**MONTGOMERY COUNTY PLANNING DEPARTMENT**  
THE MARYLAND-NATIONAL CAPITAL PARK AND PLANNING COMMISSION

**MEMORANDUM**

**PROJECT:** Seminary Road Intersection Improvements  
CIP Project No. 509337

**REVIEW TYPE:** Mandatory Referral No. MR2010813

ATTACHMENT 3

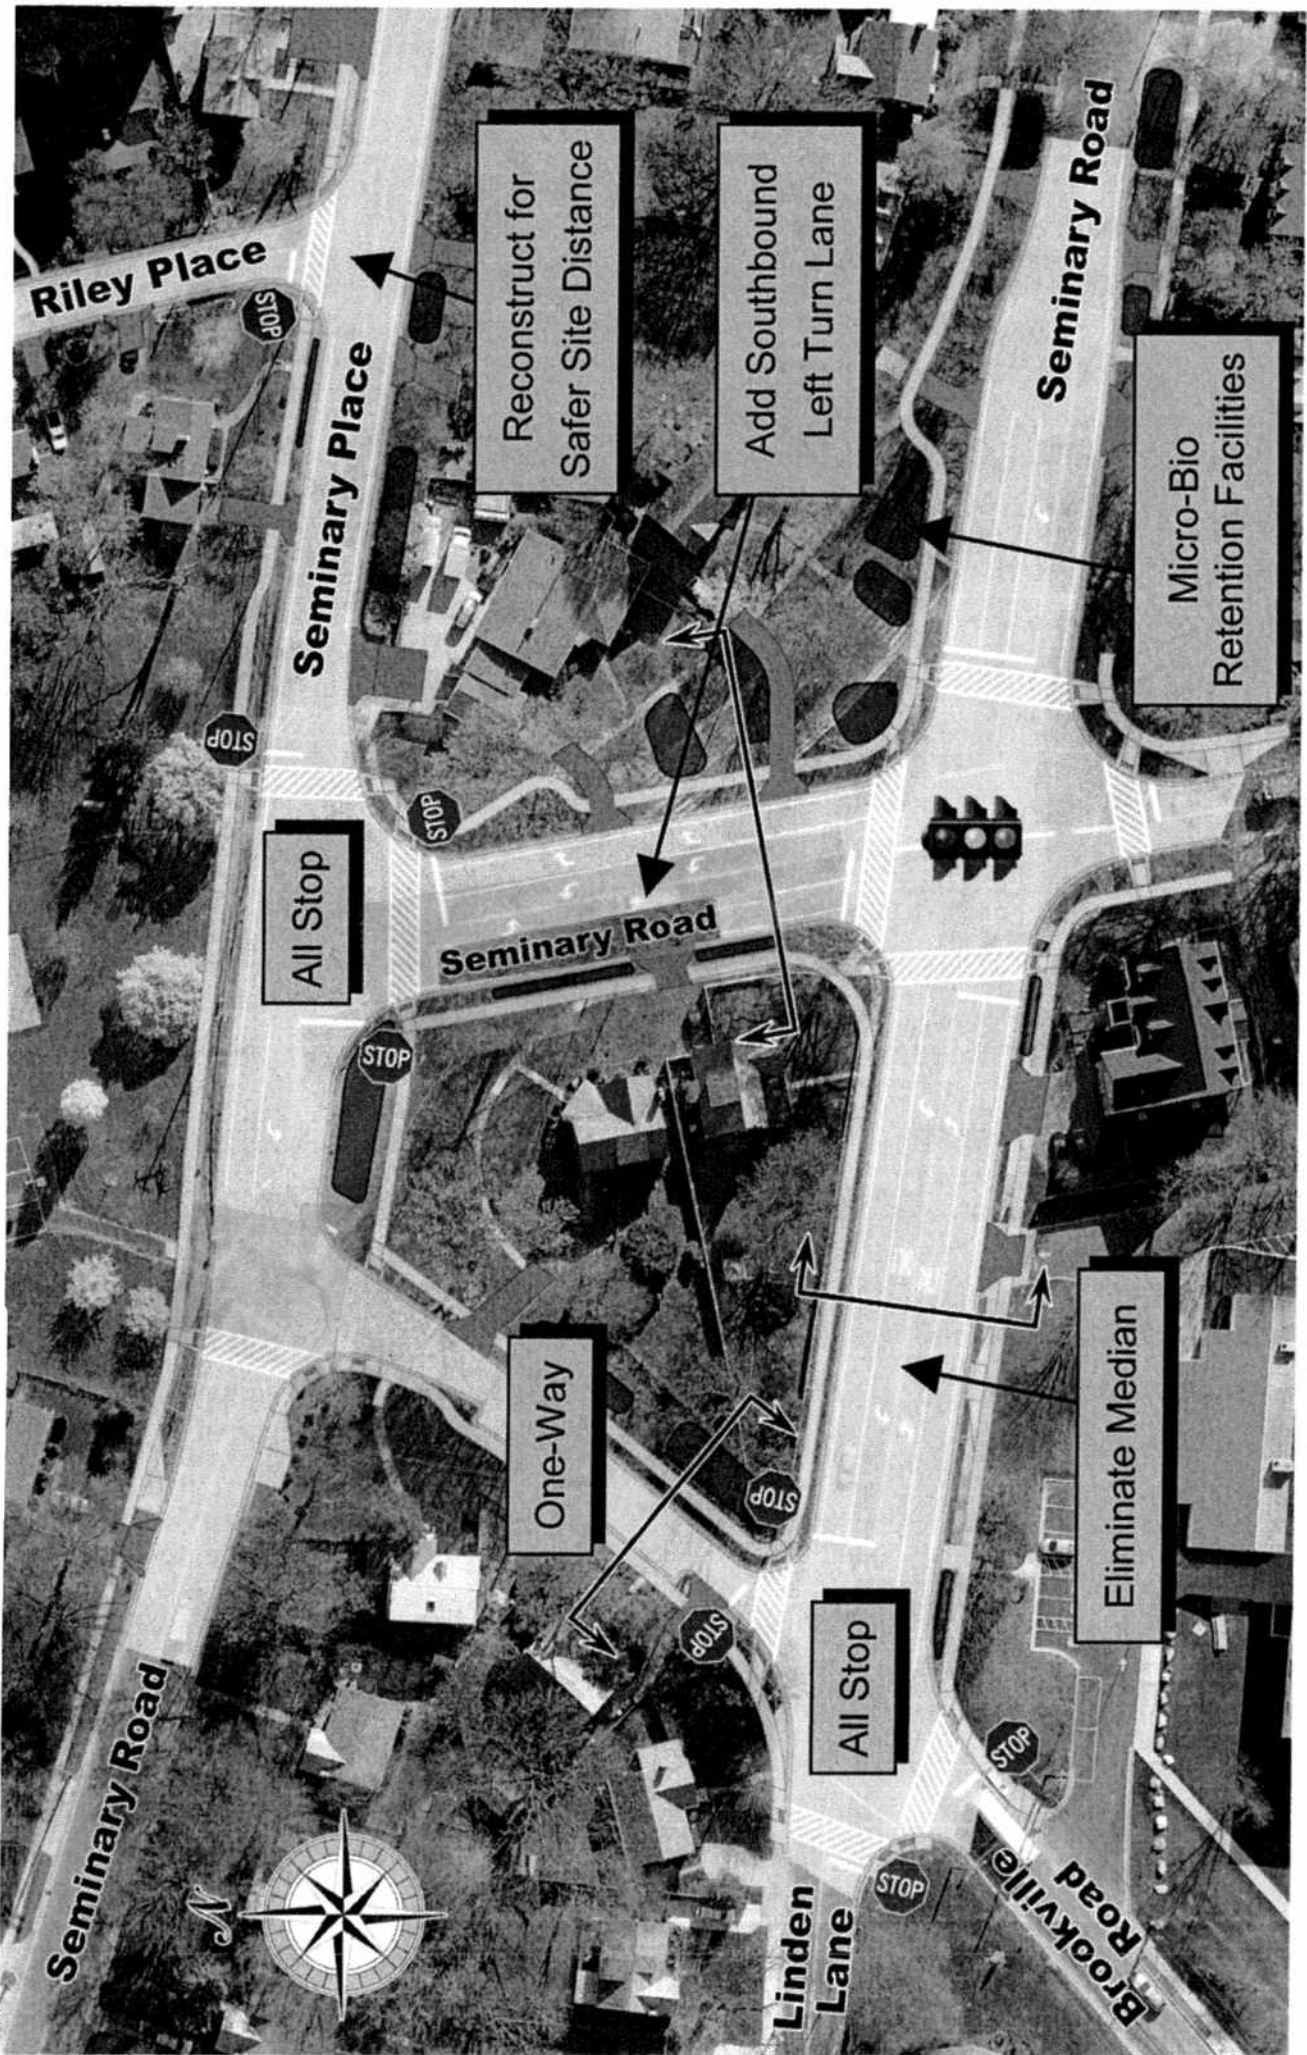
The concept presented to the public also included STOP controls for the intersection of Seminary Road with Brookeville Road. Subsequent to the public meeting, MCDOT has determined that this intersection would operate better without the all-way stop control, a change that is now reflected in Attachment 3. Staff concurs with this revision as the two northern intersections are too closely spaced to function well if both are all-way stop controlled.

Note: This graphic has been revised from what MCDOT showed at the public meeting to reflect the elimination of All-Stop control at the Seminary Road/Brookville Road intersection.

**Typical Sections: Concept 4C- REVISED Since June 2008**

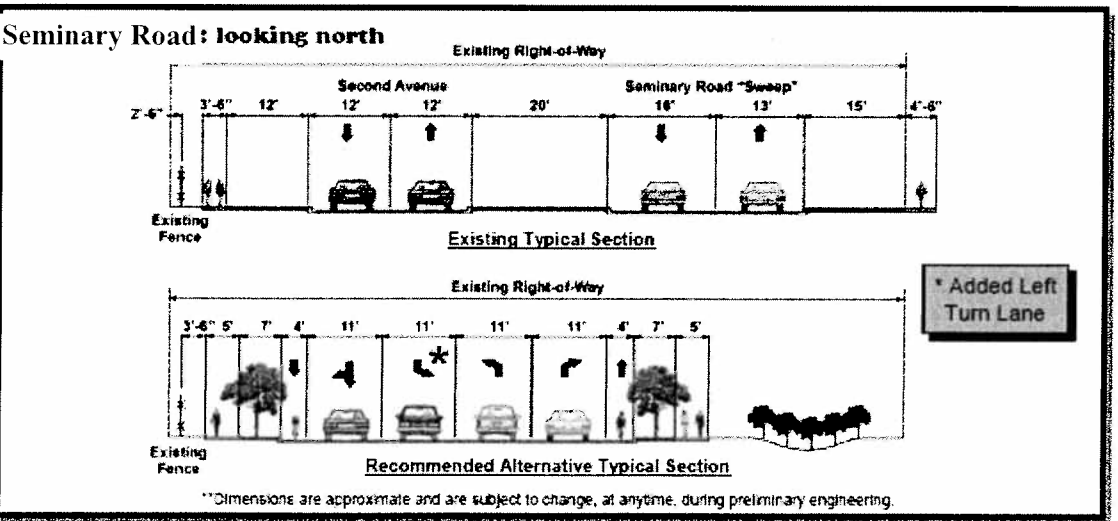
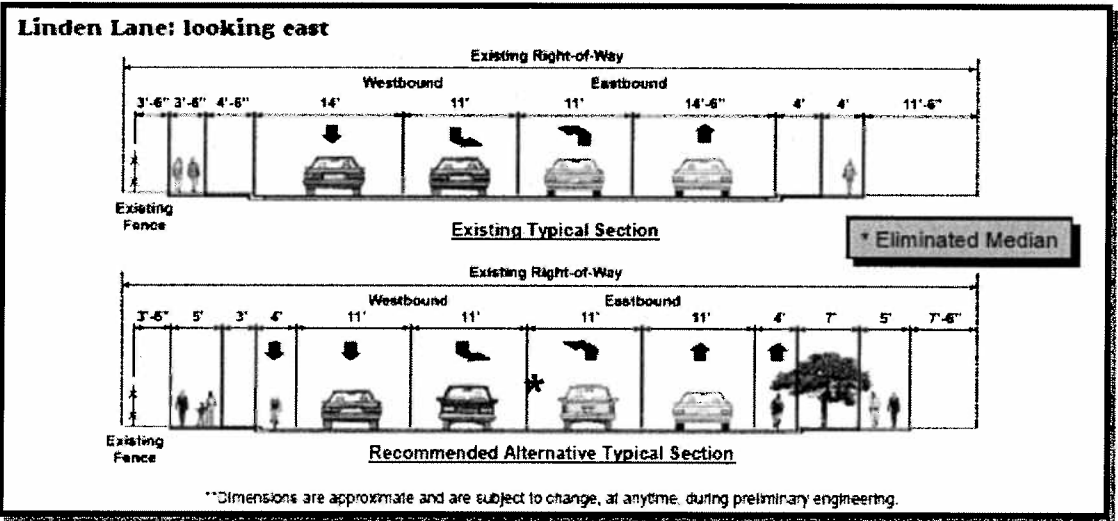
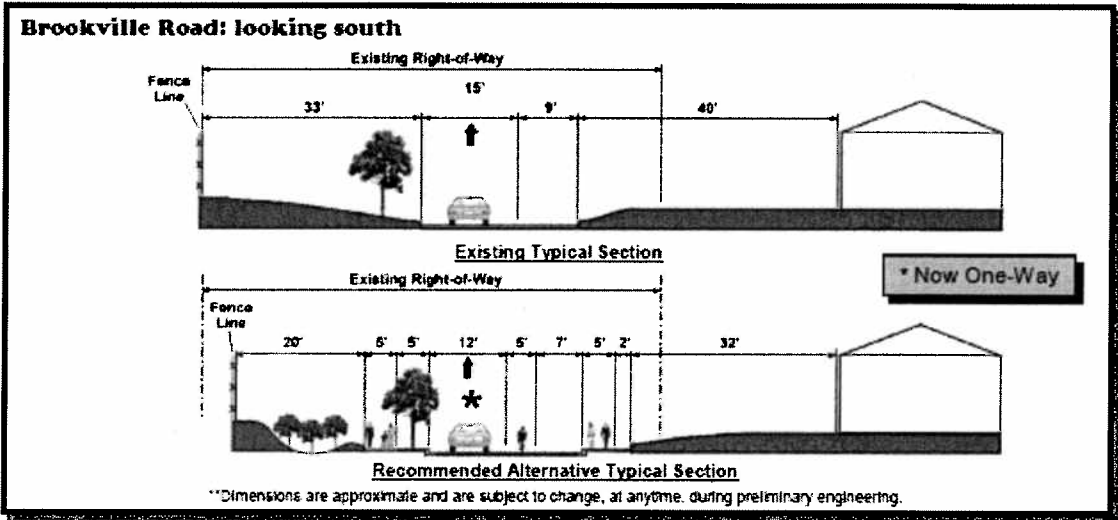
Typical sections for the area roadways under the recommended improvements are shown in Attachment No. 4.
